Application for DCO by FOSSE GREEN
Representation by Interested Party reference F88728215
Deadline 6

Summary of Submissions

Section A Comments on REP5A-038 Applicant's Response to Deadline 5 submissions

View of the tower of the Church of St Michael and All Angels from Clay Lane, Bassingham 29 May 2026

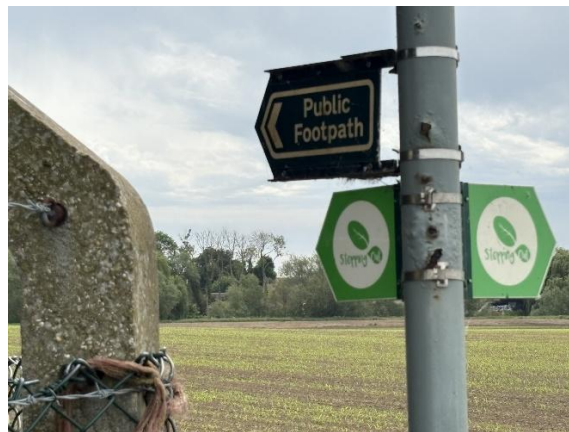
8.2.3 In considering the application of these criteria to the users of Clay Lane and Bassingham Road, paragraph 16 “Key views and vistas” of Bassingham Conservation Area Appraisal 2016 states:- “Bassingham was originally an agricultural settlement and the village is surrounded by flat, fertile farmland, with the River Witham to the west. Wider countryside and riverside views exist from Church bridge. Looking towards the village from the open countryside to the west of the river, striking views of the crenellated tower of the Church of St Michaels and All Angels are visible above riverside shrubbery”. Thus the importance of the views towards and from Bassingham Conservation Area and the Grade II* Listed Building of St Michael and All Angels Church is acknowledged in the Conservation Appraisal. Views of the church tower described in the Conservation Appraisal can be seen along Clay Lane:-

a) Visitors using the Stepping Out Walk here are likely to be focused on the landscape and particular views across the open fields towards the church tower as they approach from Norton Disney. These views are specifically mentioned in the description of this part of the route in the tourist literature.
